**SSD 8636: ENGINEERING & TECHNOLOGY PRECINCT DEVELOPMENT
UNIVERSITY OF SYDNEY, DARLINGTON CAMPUS**

UNIVERSITY OF SYDNEY RESPONSE TO SUBMISSIONS

21 SEPTEMBER 2018

THE UNIVERSITY OF SYDNEY ETP STAGE 1
 Electrical Engineering Building
 University of Sydney, NSW 2008
 FLOOR PLAN - LEVEL 01 (SHEET 02 OF 02)
 A-DA-2101B

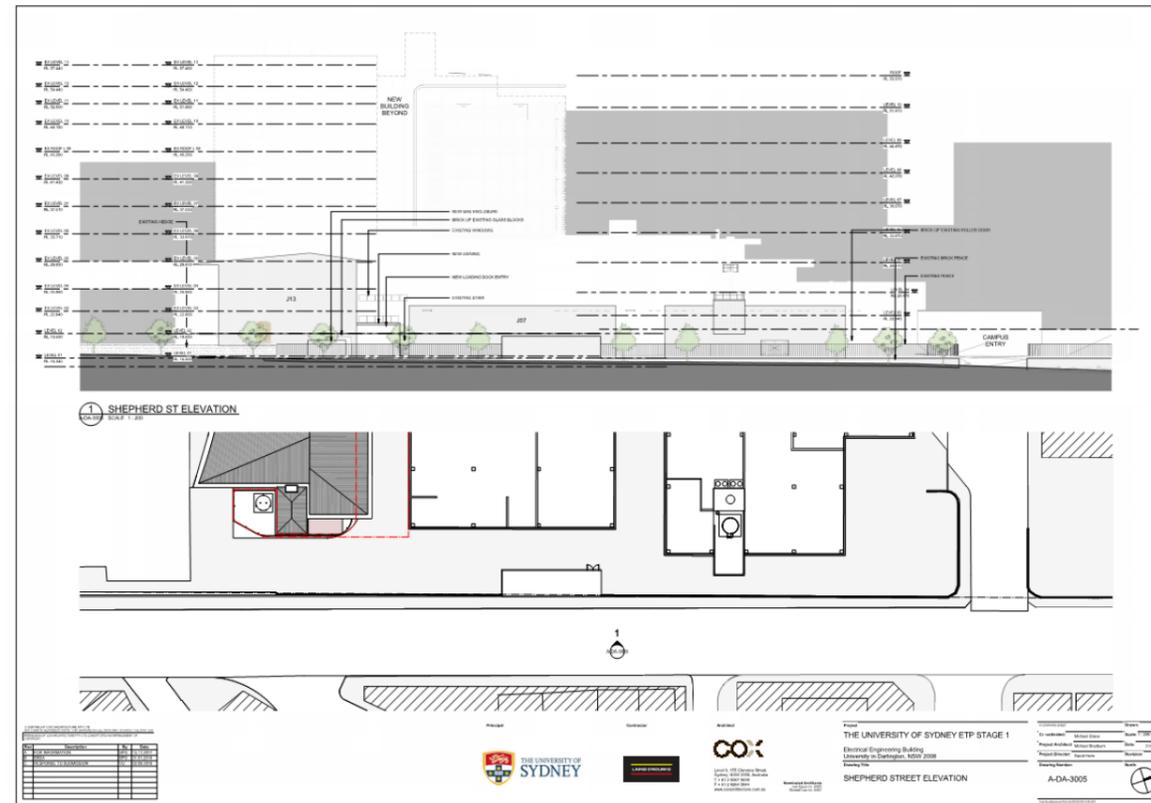
13. Objection to appearance of ugly sheds and plant rooms fronting Shepherd Street. (1 submission)	<p>Please refer to the drawing A-DA-2101B & A-DA-3005 (page 6 & 20) in Appendix A - Revised Architectural Plans for proposed VIE tank location. A more consolidated location and improved screening has been added to address the resident concern regarding appearance.</p>

SSD 8636 – ENGINEERING & TECHNOLOGY PRECINCT DEVELOPMENT	
CoS ISSUE	UNIVERSITY OF SYDNEY PROJECT RESPONSE
	<p>Shepherd Street (in accordance with the City of Sydney’s bicycle access plan – see below). The University does not assign specific “cycle only” lanes within the campus and therefore no specific bicycle path is considered necessary within the development site area.</p> 
<p>7. Heritage & Urban Design</p> <ul style="list-style-type: none"> Two gas stores and a ‘vie tank’, which is two storeys in height and screened only by a security fence are proposed along the Shepard Street frontage. Concerns are raised that these structures give a poor ‘back of house’ presentation and will detrimentally impact the appearance of the building from the street and residences opposite. It is recommended that these structures are relocated so as not to be visible from the public domain. 	<p>Please refer to the drawing A-DA-2101B & A-DA-3005 (page 6 & 20) in Appendix A - Revised Architectural Plans for proposed VIE tank location. A more consolidated location and improved screening has been added to address the resident concern regarding appearance.</p>

Fig 2 - Modular repeated structure

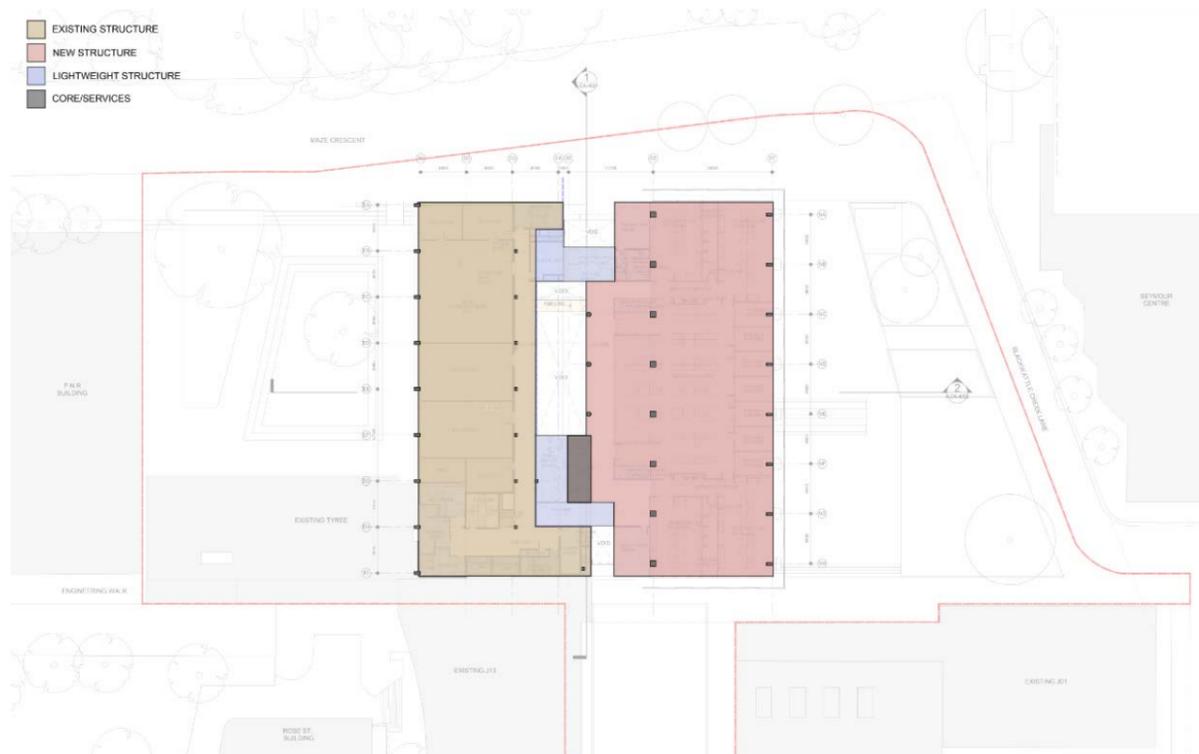
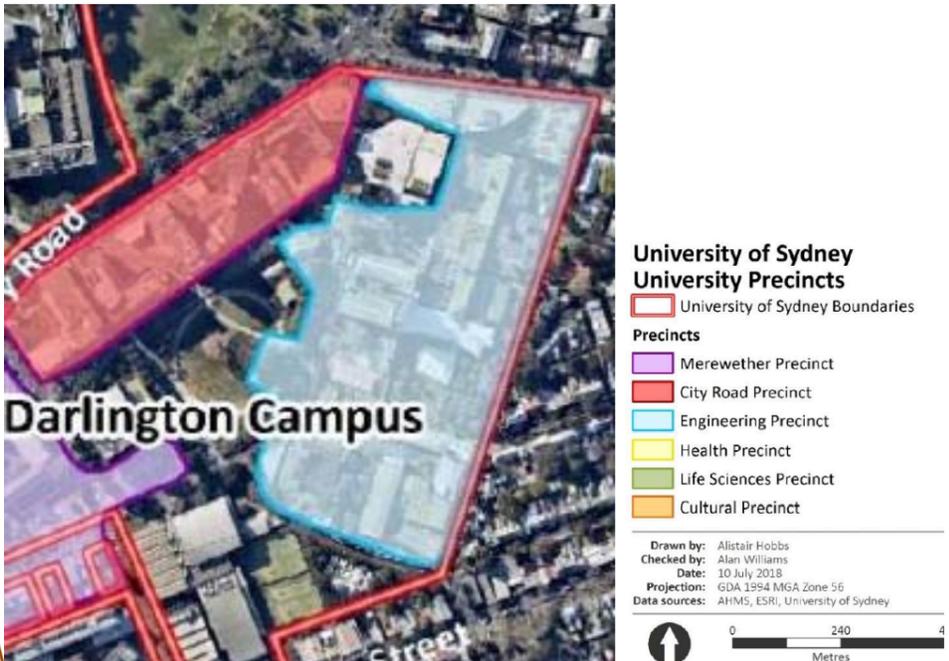
- Department are encouraged to impose a condition requiring submission of a photographic archival record of the existing building to be carried out in accordance with NSW Heritage Division guidelines prior to the commencement of works and a copy of the record lodged with the University Archives.
- In addition, it is recommended that any original features that are part of the stylistic character of the late 20th century Brutalist Style building should be retained as part of the upgrade works.

The design retains and reveals the existing elements that exemplify the brutalist style. The design employs the philosophy of expressing raw material in repeated modules on the new structure, whilst still acknowledging the heritage design of the existing building.

- Expose the existing shuttered concrete & face brick surfaces where ever possible
- Creates a new, modular, repeated structure that references the philosophy of the original structure; and
- Uses a palette of raw self finished raw materials

Figure 1 ETP site location

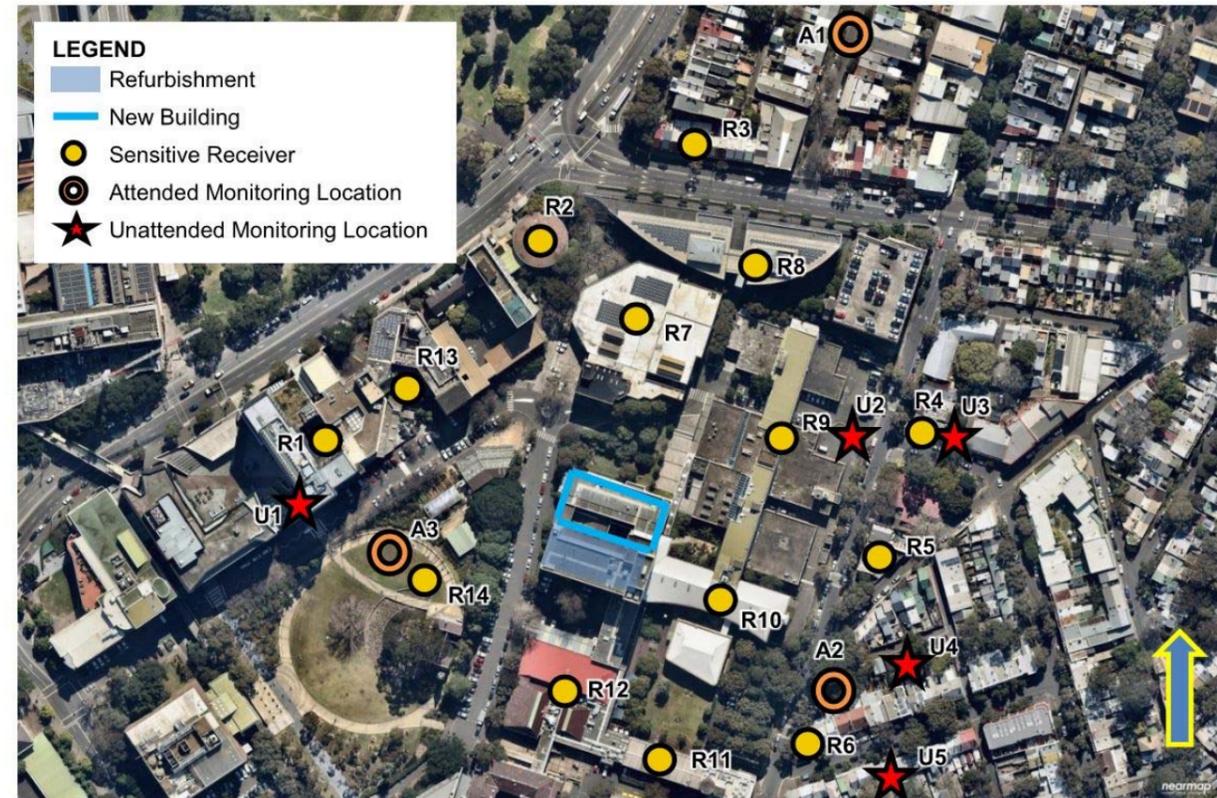
<p><u>Noise and Vibration</u></p> <p>Recommendation 10: The proponent be required to ensure that as far as practicable all demolition, site preparation, construction and construction-related work likely to be audible at any noise sensitive receivers, including residences and residential colleges, is undertaken only during the standard construction hours, being -</p> <p>(a) 7.00 am to 6.00 pm Monday to Friday,</p> <p>(b) 8.00 am to 1.00 pm Saturday, and</p> <p>(c) No work on Sundays or gazetted public holidays.</p>	<p>Conditional agreement: The University requests that the same hours of works be applied as those that were approved for other recently approved university SSD projects including FASS F23 and LEES1 projects fronting City Road, and comprising (proposed changes highlighted in red):</p> <p>a) 7.00 am to 6.00 pm Monday to Friday,</p> <p>b) 7:30 am and 3:30 pm Saturday, and</p> <p>c) No work on Sundays or gazetted public holidays.</p>

A number of noise and vibration-sensitive land uses are located in the immediate vicinity of the Stage 1 site as shown in Figure 1, with the most significant being existing University buildings. The nearest residential land uses are the Urbanest Darlington Student Accommodation to the west (represented by R1), the residences on the eastern side of Shepherd Street (represented by R4, R5 and R6) and the residences on the northern side of Cleveland Street (represented by R3).

Reference (see Figure 1) and	Description
Residential buildings	
R1 – Urbanest Darlington	Residential land uses 80 m away or more from new building. Cleveland Street and Shepherd Street residences shielded by intervening buildings.
R2 – International House	
R3 – Cleveland Street	
R4 – Shepherd Street	
R5 – Shepherd Street	
R6 – Calder Road residences	
University of Sydney buildings	
R7 – Seymour Centre	Performing Arts Centre within the University of Sydney, approximately 45 m north of the new
R8 – Warren Centre	Various University buildings associated with Engineering Faculty that surround the project site.
R9 – Mechanical Engineering	
R10 – Engineering Link	
R11 – Civil Engineering	
R12 – PNR Building	
R13 – Wentworth Building	Faculty of Architecture, Design and Planning
Recreational land uses	
R14 – Cadigal Green	Public recreation area. Includes heritage-listed Old School building on Maze Crescent.

2 WINTER SOLSTICE - 3PM Existing Building
SCALE 1 : 750

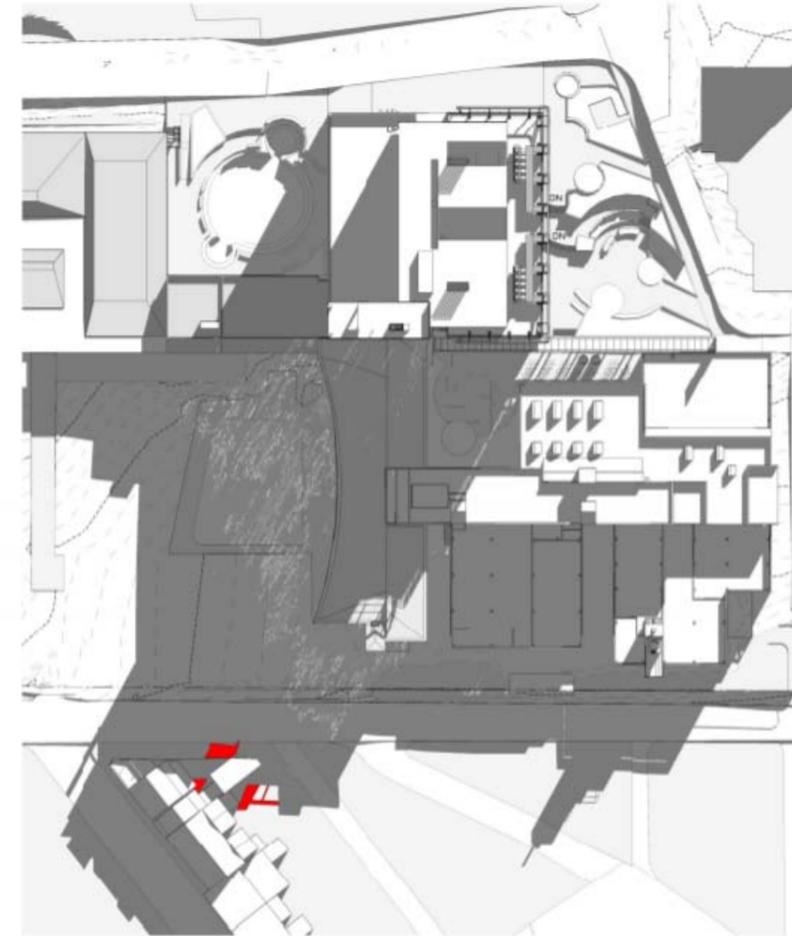
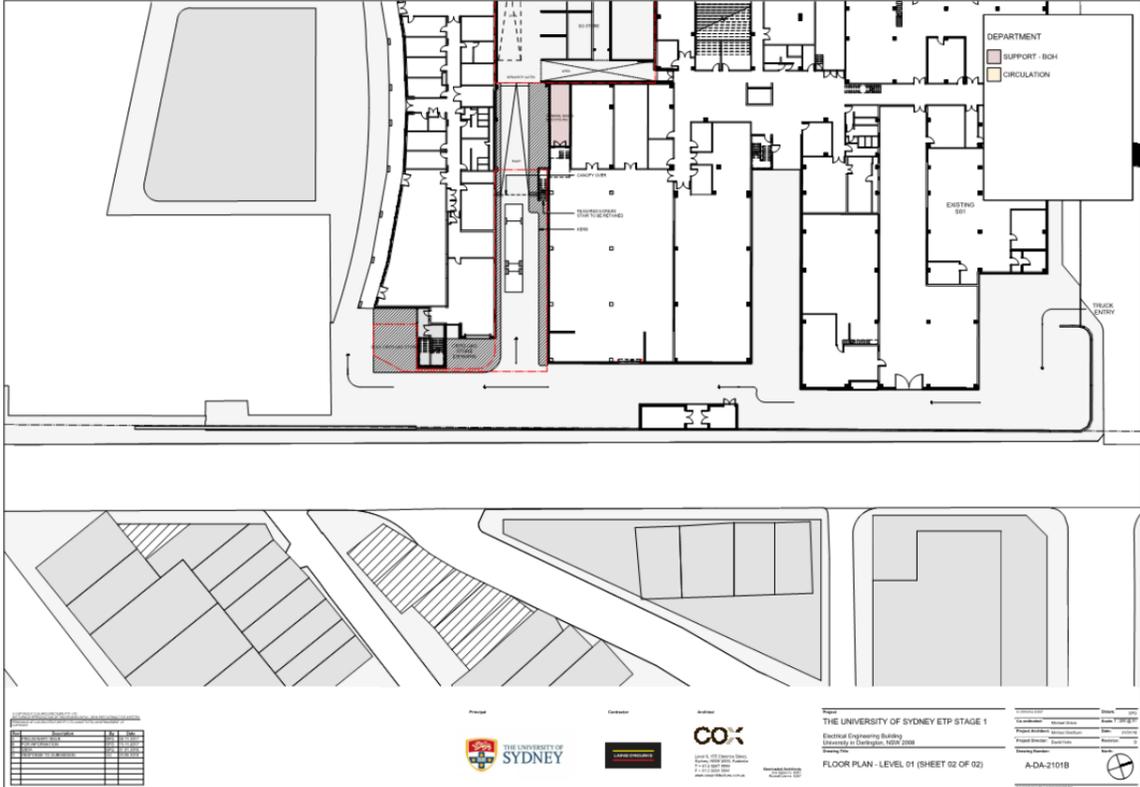
SSD 8636 – ENGINEERING & TECHNOLOGY PRECINCT DEVELOPMENT	
ISSUE	USYD PROJECT RESPONSE
<p>DPE has received a total of 10 public submissions in response to the public exhibition process – 1 in support of the SSD proposal and 9 submissions citing objections. Three (3) of the objections are from anonymous sources.</p> <p>The University's RtS has sought to list the issues of objection in order of frequency rather than listing each submission in turn. This has assisted the University in identifying common and individual issues as well as avoiding repetition in this RtS report.</p>	
<p>1. Noise and vibration impacts from construction upon Shepherd Street residents. (5 submissions)</p>	<p>Noted: The University relies upon, and will comply with, the relevant standard SSD consent conditions applied to the SSD consent addressing construction hours, noise and vibration.</p>
<p>2. Will not support service vehicle traffic from the loading dock for over 2 tonne vehicles on to Shepherd Street. Shepherd Street is too narrow (4 metres wide) for large trucks. (4 submissions)</p>	<p>Disagree: Based on research undertaken by GTA Consultants, it is understood that many SUV / larger size passenger vehicles are over 2 tonnes. A selection of such vehicles includes:</p> <ul style="list-style-type: none"> - Nissan Murano – 2.3 tonnes - Toyota LandCruiser – between 2.1 to 2.6 tonnes - Porsche Cayenne S Hybrid - 2.3 tonnes - Ford Territory – between 1.9 to 2.1 tonnes - BMW X5 – 2.1 tonnes <p>The above mentioned vehicles are within the dimensions of an 85th percentile vehicle, as per Appendix B of AS/NZS2890.1:2004 Part 1: Parking facilities: Off-street car parking.</p> <p>If access to Shepherd Street is to be restricted to vehicles over 2 tonnes, effectively, access to Shepherd Street will be restricted to a range of common light vehicles.</p> <p>Notwithstanding, the University intends that access to / from the loading dock is proposed to be primarily via Butlin Avenue / Maze Crescent intersection, connecting to Blackwattle Creek Lane to access the service vehicle access route that is located to the east of the Mechanical Engineering Building.</p>

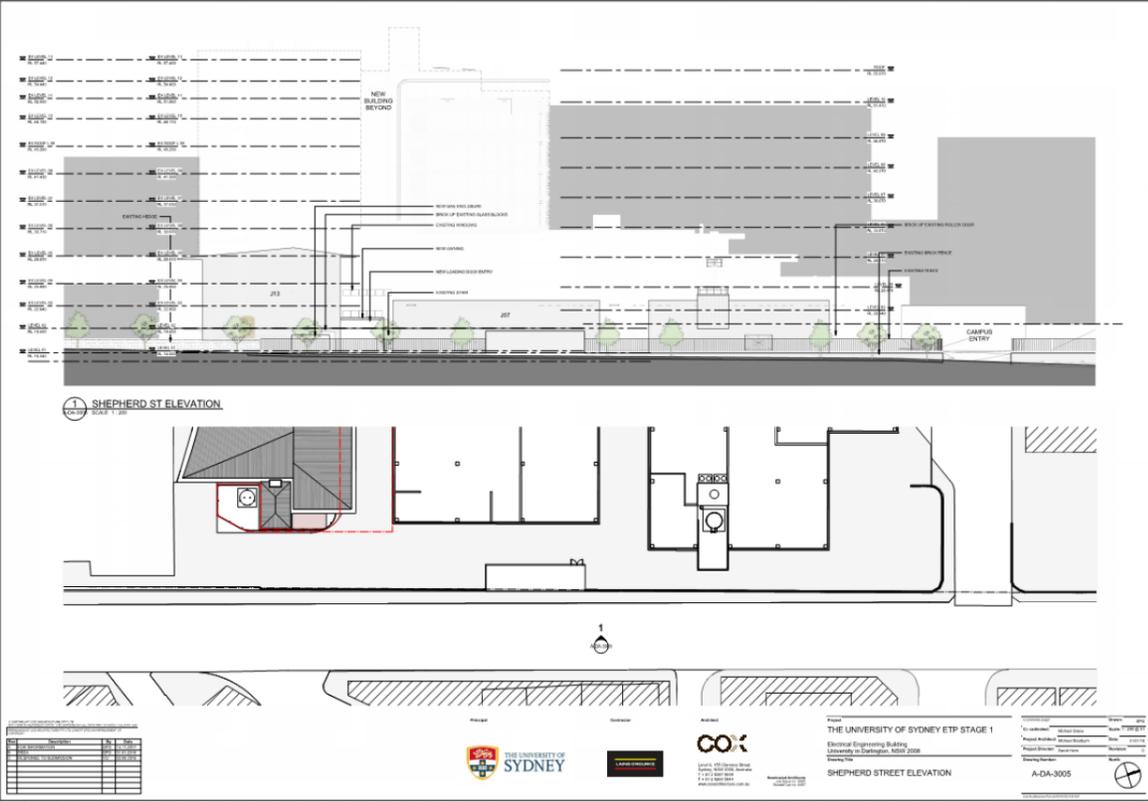
4. Protection sought for Tallowood Grove trees on the Engineering car park (Rose Car Park) from passing trucks. (2 submissions)

MRV/HRV vehicles entering and exiting the loading dock are to travel via Maze Crescent, and consequently there will be no impact on Tallowood Grove trees on the Engineering Car Park.

Only SRV vehicles will exit via Shepherd Street. The swept path assessment undertaken for SRV confirms that no trees will need to be removed or modifications required to be made to the footpaths that run along the Civil Engineering Building frontage.
